December 13, 2012

**RE: Safety-Kleen Systems, Inc. Medley; FLD 984 171 694, Operating Permit No. 56019-
HO-007, Miami-Dade County
First Notice of Deficiencies Dated November 14, 2012**

Safety-Kleen (SK) has prepared this letter in response to the above referenced letter from the Department dated November 14, 2012. We have identified each of the Departments comments in bold, followed by our response. Revised pages of the application are enclosed with this submittal.

FIGURE 2.2-1 Topographic Map Safety-Kleen Systems, Inc. Facility Medley, Florida

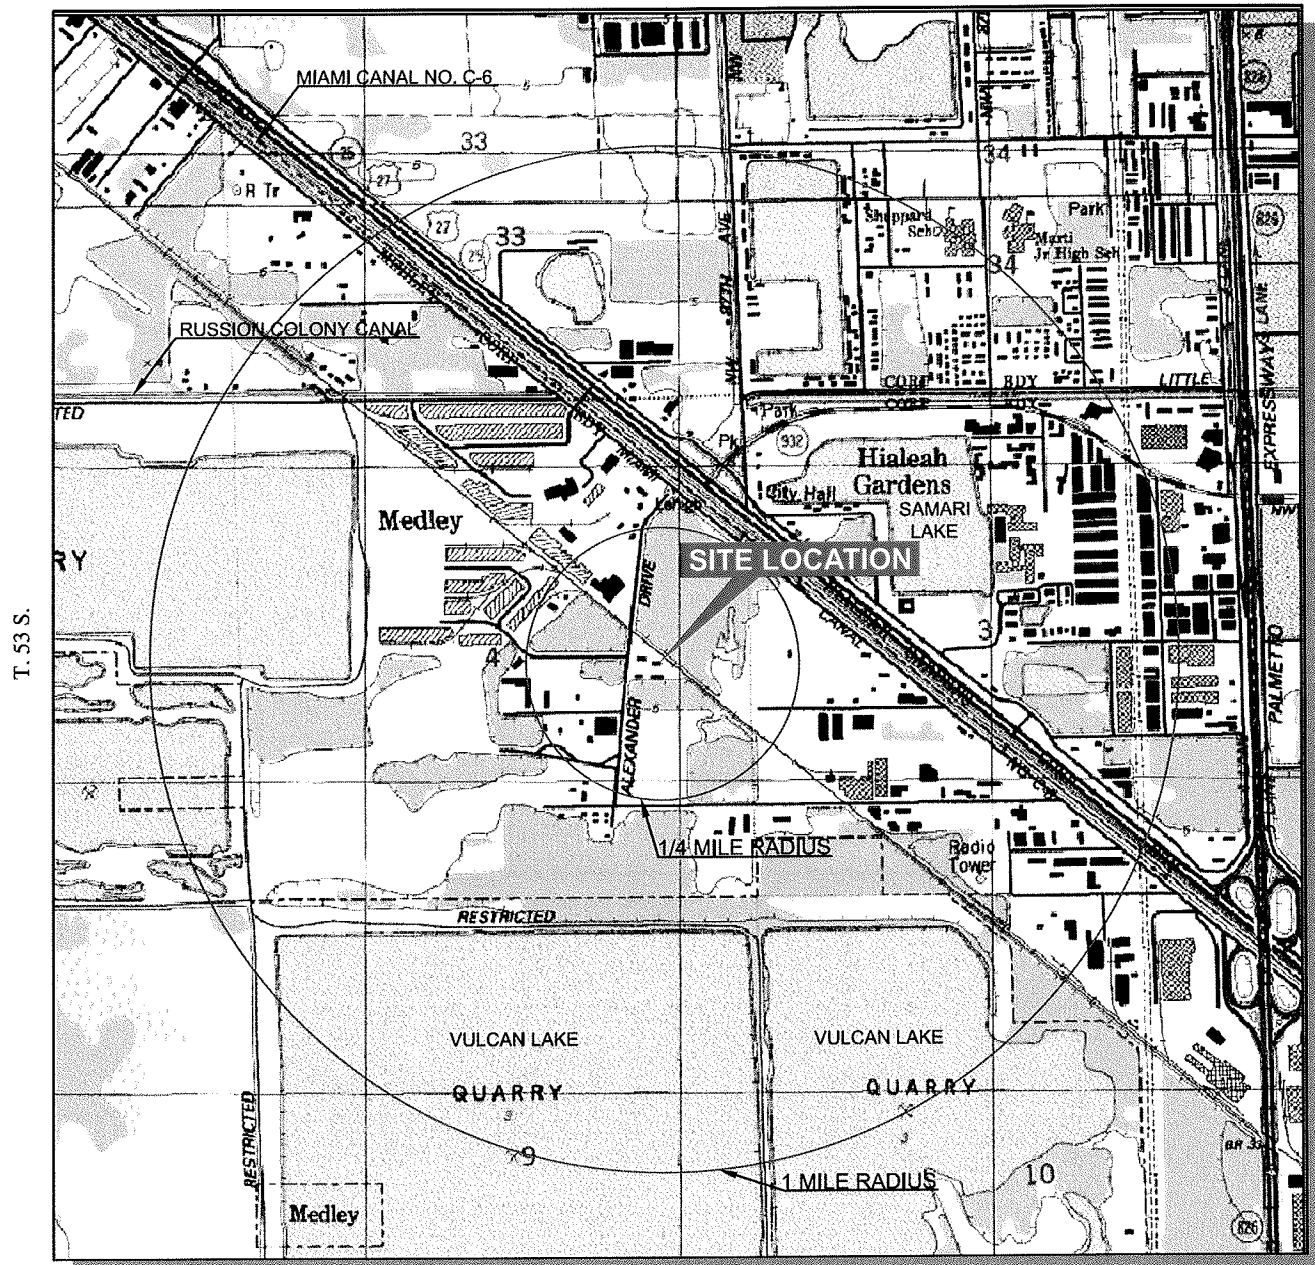
FDEP Comments #2: Figure 2.2-1: It is nearly impossible to identify with certainty, the surface water bodies.

SK Response: Figure 2.2-1 has been revised.

FIGURE 2.2-2 SITE LOCATION MAP SAFETY-KLEEN FACILITY MEDLEY, FLORIDA

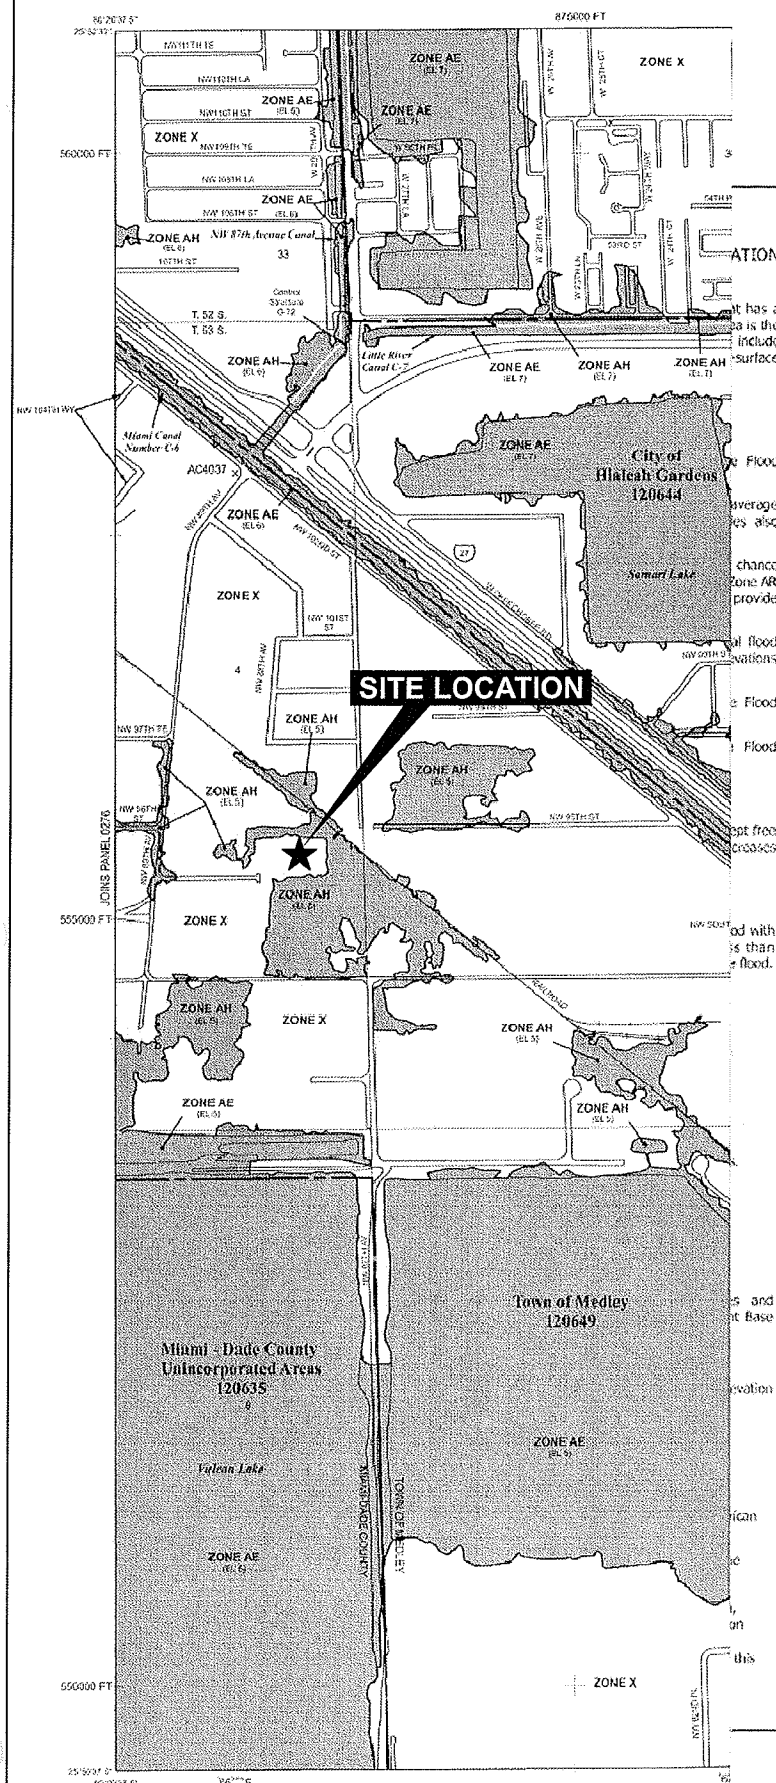
FDEP Comments #3: Figure 2.2-2: It is not possible from the figure to determine which flood zone was determined for the property. At a minimum, the Zone the property lies within and its boundaries must be identified. Also, ensure that the legal identifies the Zones.

SK Response: Figure 2.2-2 has been revised.

Figure 2.2-3
Surrounding Land Use Map
Safety-Kleen Systems, Inc. Facility
Medley, Florida

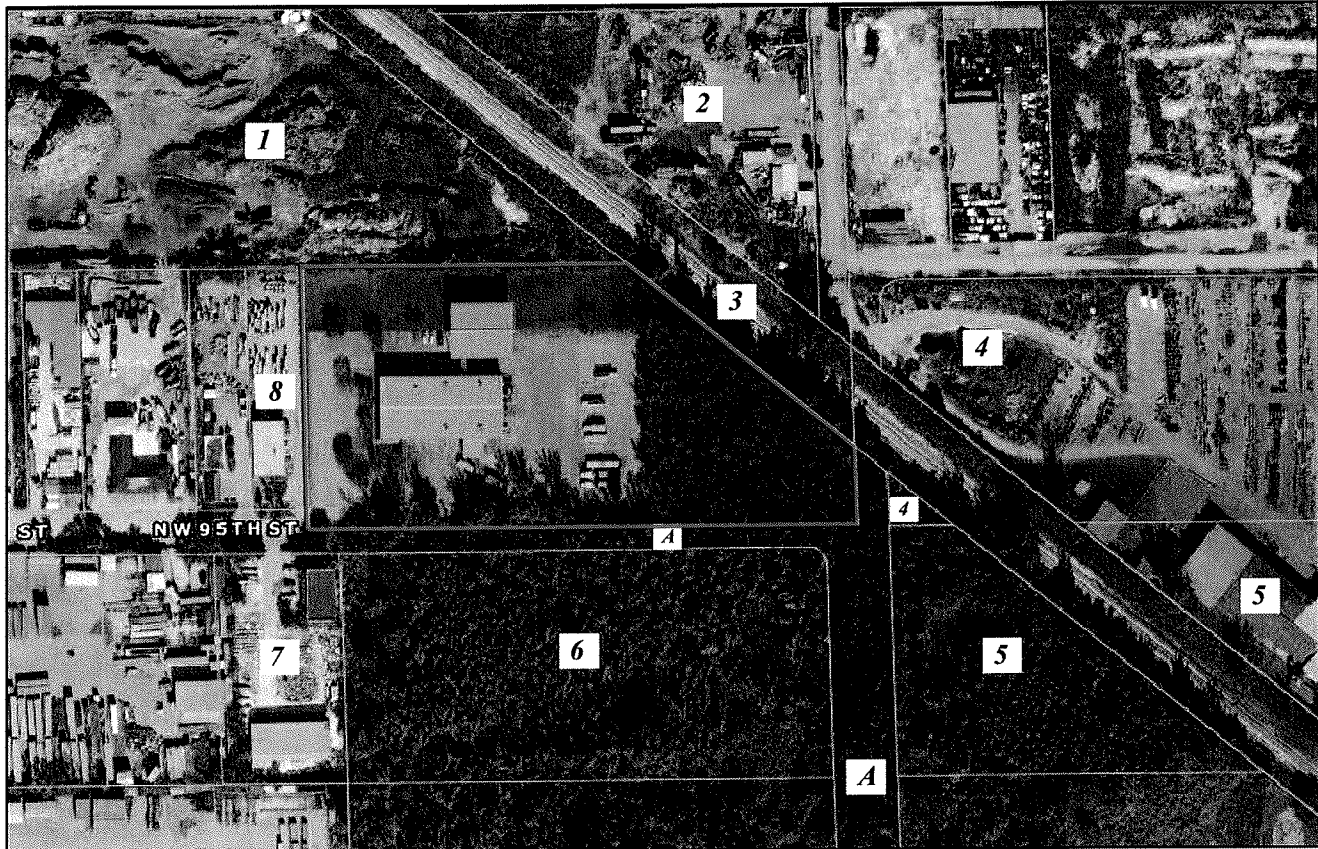
FDEP Comments #4: Figure 2.2-3 is not a Surrounding Land Use Map; rather, it identifies the property owners. The figure should be updated to indicate land use. There also appears to be an unidentified piece of property adjacent to the southeast corner of the Safety-Kleen property (appears to be a right of way). Its land use must be identified. Also, check to see if properties 4 & 5 should be U.S. Holdings, Inc. rather than U.S. Assets, Inc., and d.b.a. U.S., rather than UN Foundry.

SK Response: Figure 2.2-3 has been revised.

Figure 8.1-1
Container Storage Area
Safety-Kleen Systems, Inc. Facility
Medley, Florida

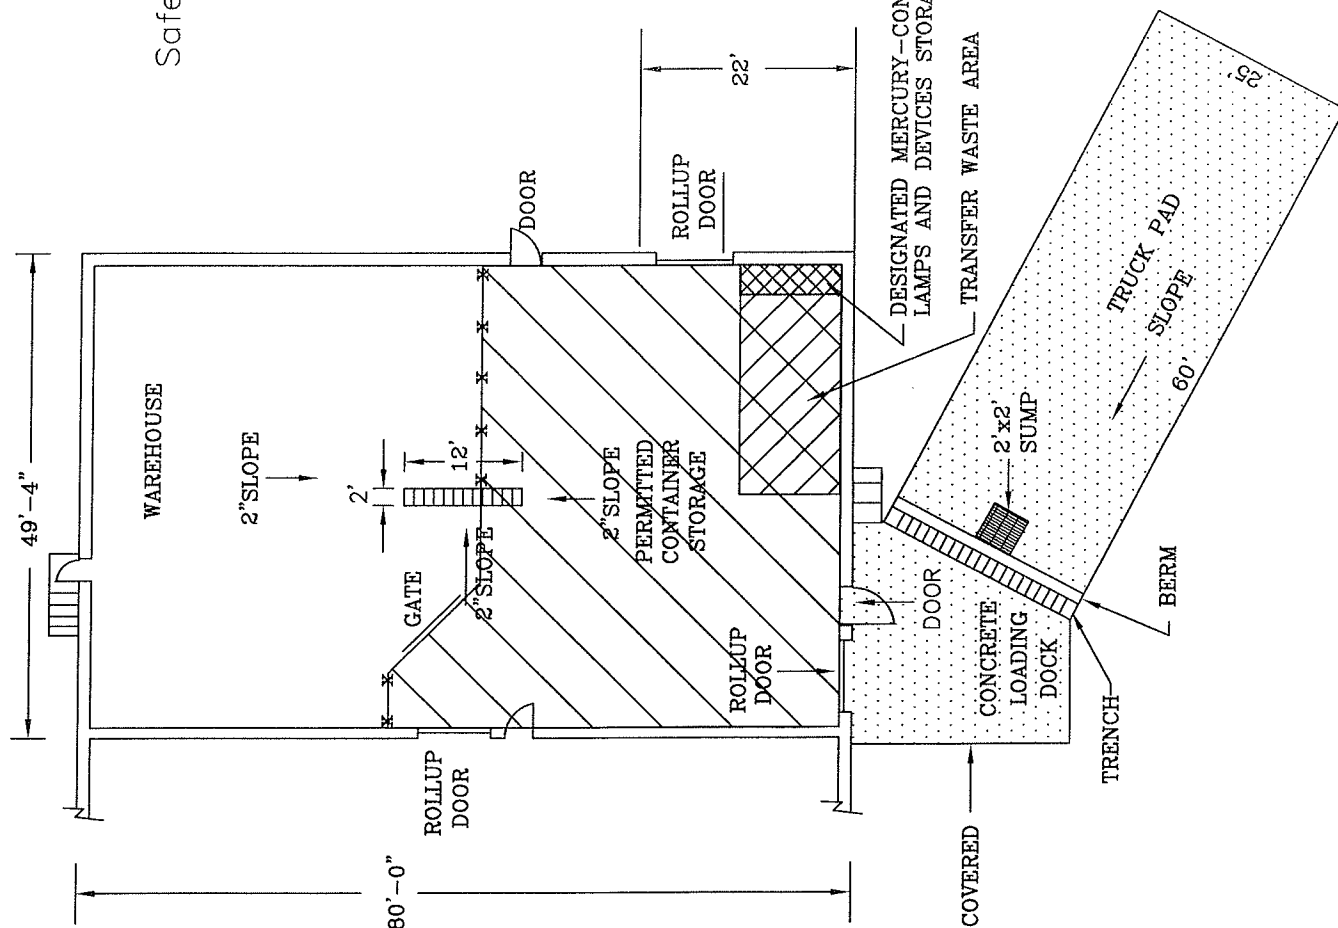
FDEP Comments #19: Figure 8.1-1: The legend contains "Area Used for Waste Transfer", and there is a "Waste Transfer Area" designated in the warehouse. We suggest that the legend be changed to "Permitted Container Storage" to avoid confusion and be consistent with the actual wording used on the hatched area within the warehouse.

SK Response: Figure 8.1-1 has been revised accordingly.

Figure Part II - Q
Locations of Solid Waste Management Units (SWMU)
Safety-Kleen Systems, Inc. Facility
Medley, Florida

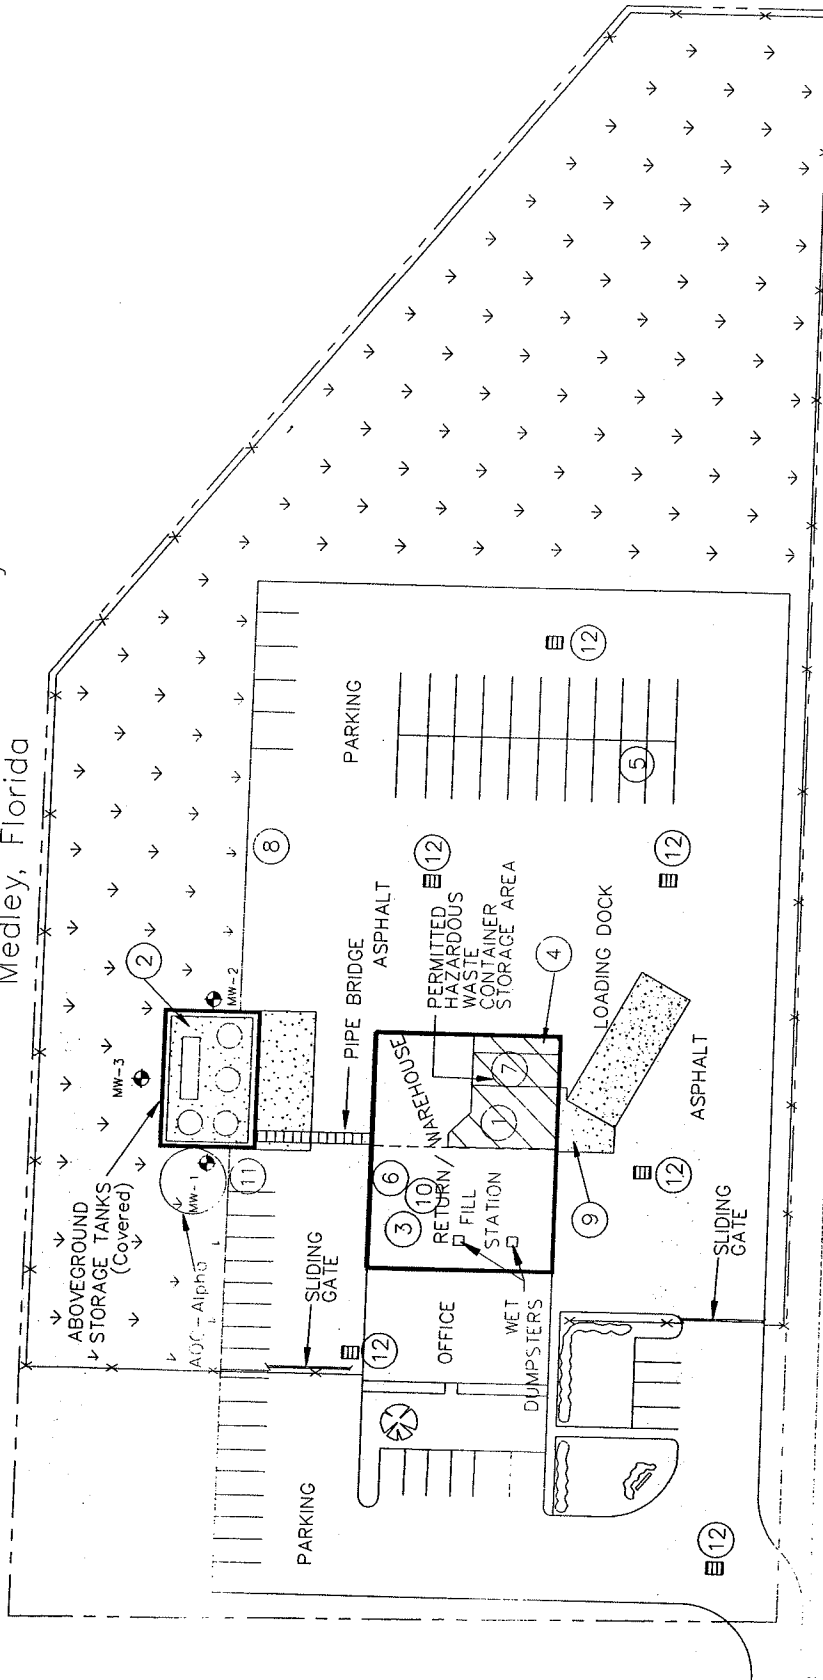
FDEP Comments #26: The SWMUs listed on pages 1 and 2 should include their formal names. The first six are included in your existing permit. SWMUs 7-10 were added as was done at Boynton Beach. Although not required, we suggest the same nomenclature be used. SWMU-11 should be the stormwater discharge area that is part of your IW permit with DERM. As you may recall, on May 23, 2012, we discussed your IW permit that allows sheen-less stormwater from secondary containment to be discharged somewhere on site. The area is required to be monitored twice a year by DERM's permit. As previously discussed, this area should be identified as a SWMU. This area must also be identified in the map that identifies each SWMU location.

FDEP Comments #27: Also, in Part II A. General –Run off Control System, there is no oil/water separator before stormwater goes to the French Drain. This French Drain functional acts as a stormwater pond in that both collects stormwater, and this French Drain should be identified as a SWMU. Parts P & Q require information for this SWMU.

SK Response: The above information has been revised accordingly. Please note that the current DERM IW permit requires SK to monitor once a year. Previously it required monitoring twice a year.

SK Response: Parts P & Q have been revised accordingly.

Figure II.C.2-1
 Tank Farm
 Safety-Kleen Corp. Facility
 Medley, Florida

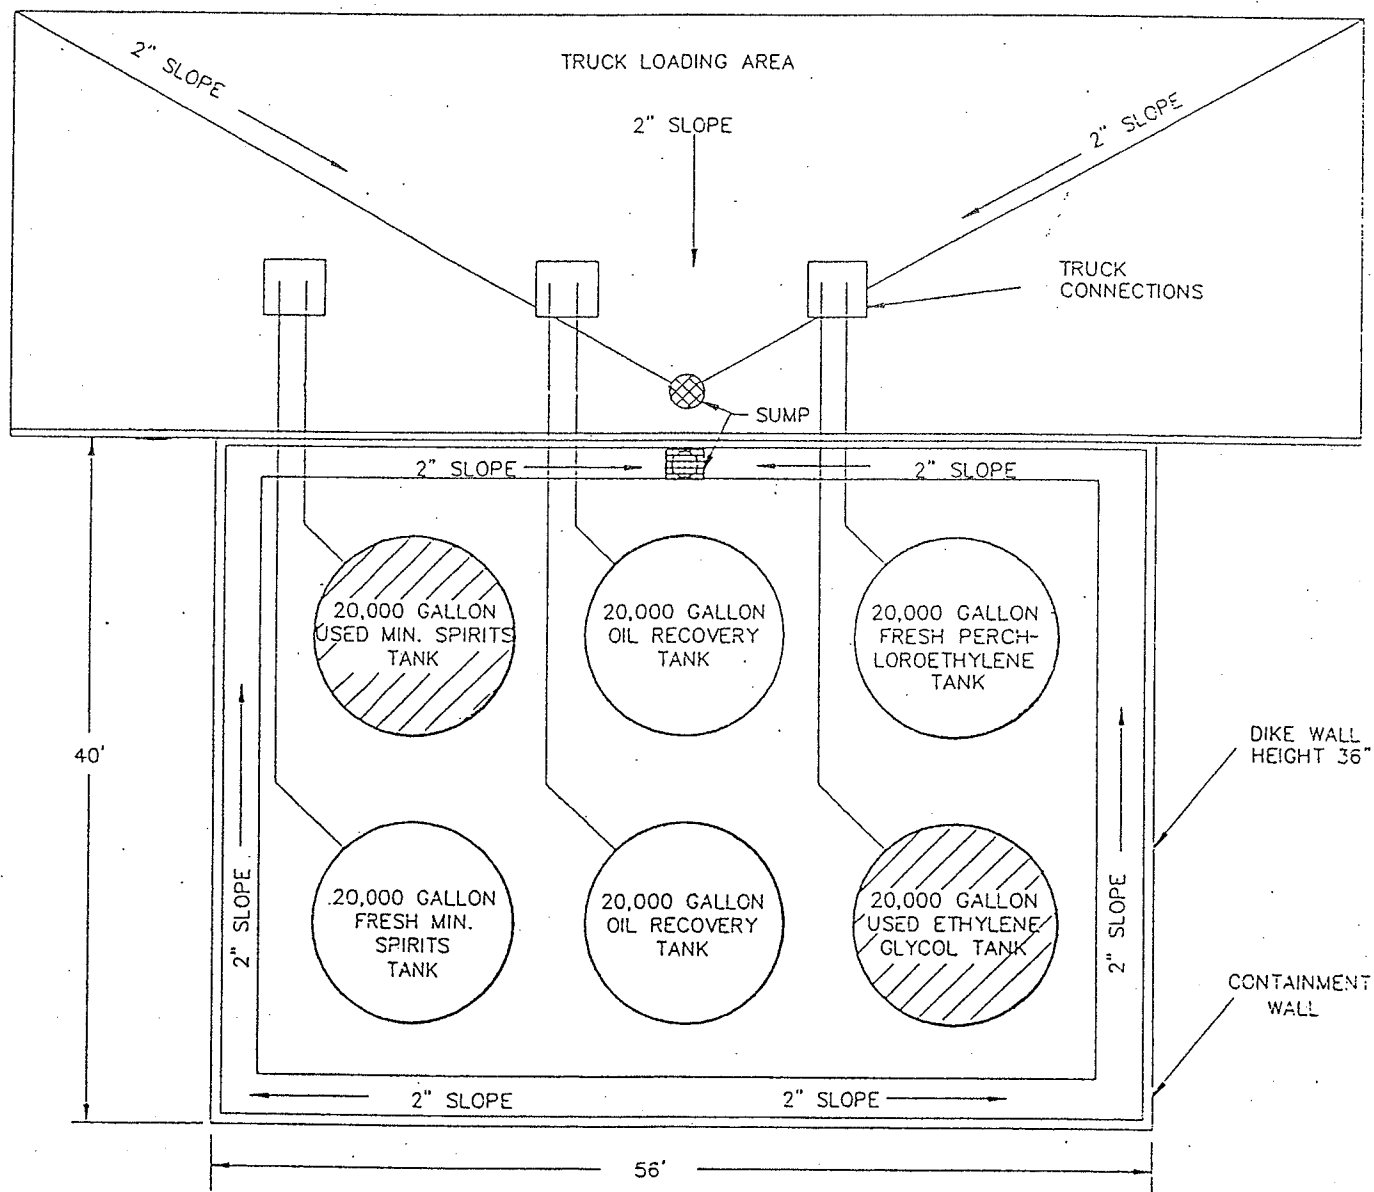
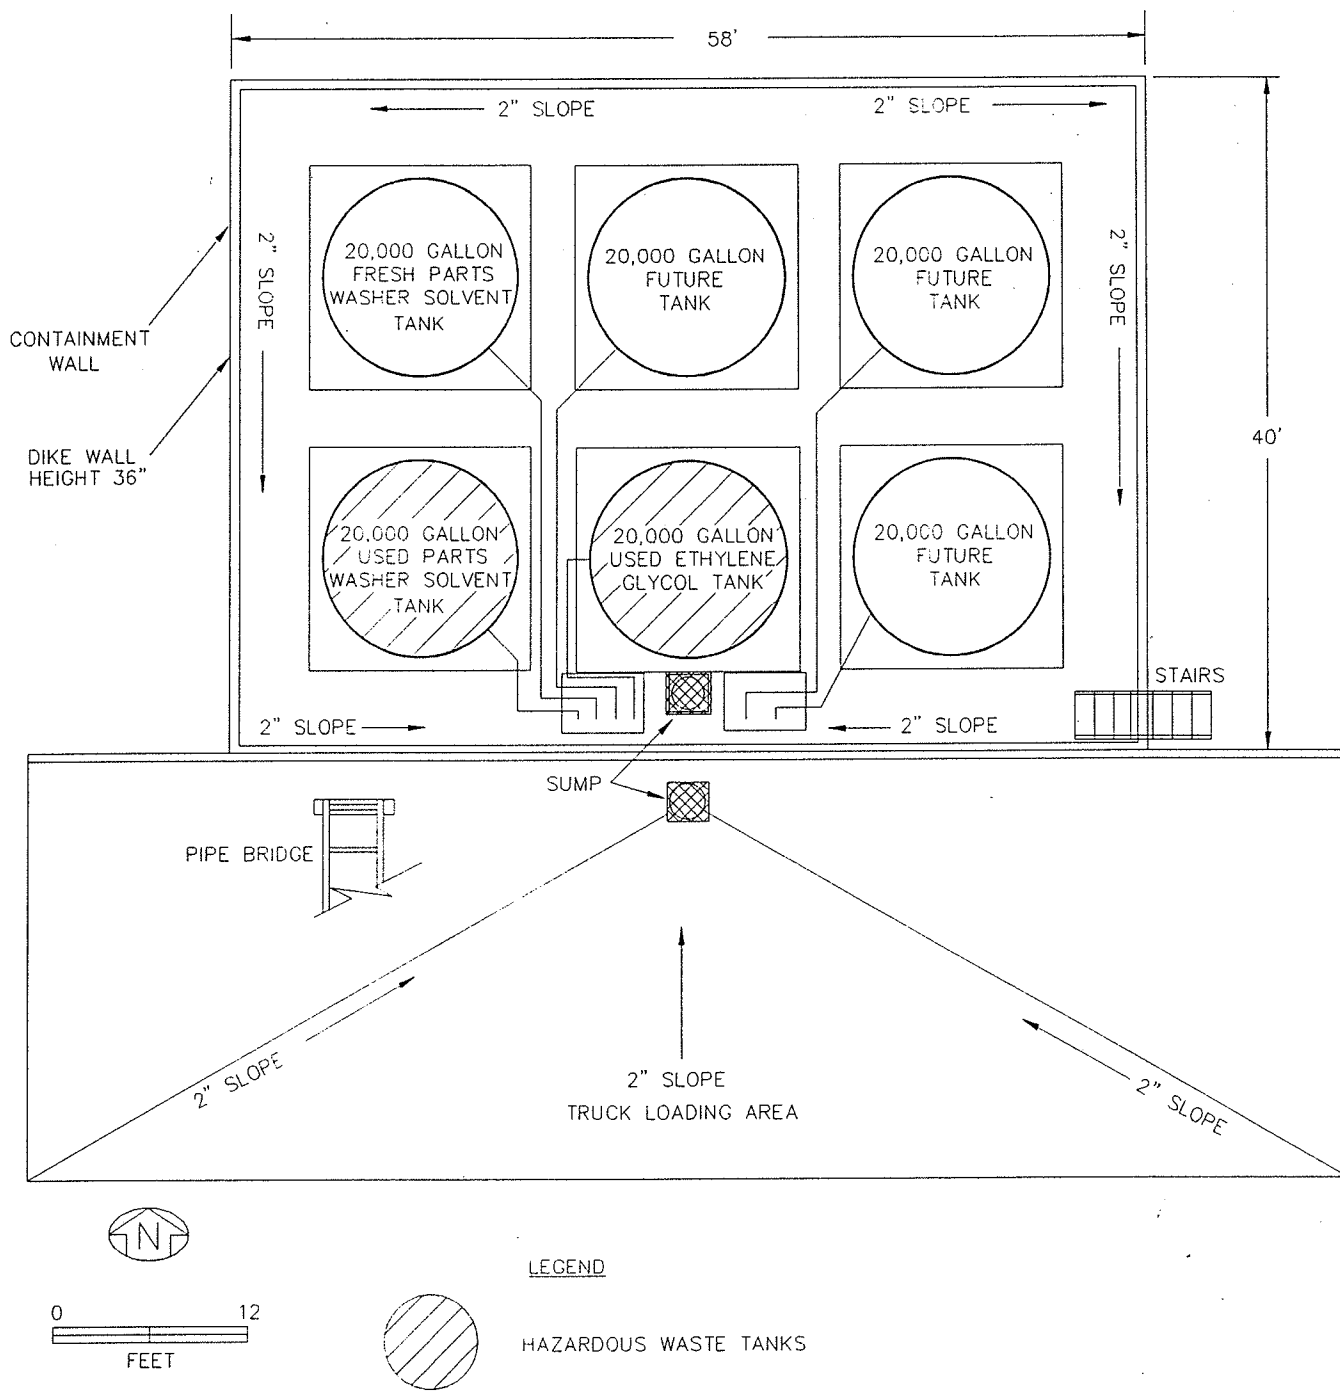
FDEP Comments #33: The engineers report lists secondary containment area for the tanks as 58 ft. by 40 ft. The figures throughout the application list the containment area as 58 ft. by 56 ft. Using the scale on these same figures the width was calculated as 40 ft. Please revise the figures to reflect this actual width.

SK Response: The figures have been revised to 40 ft. width.
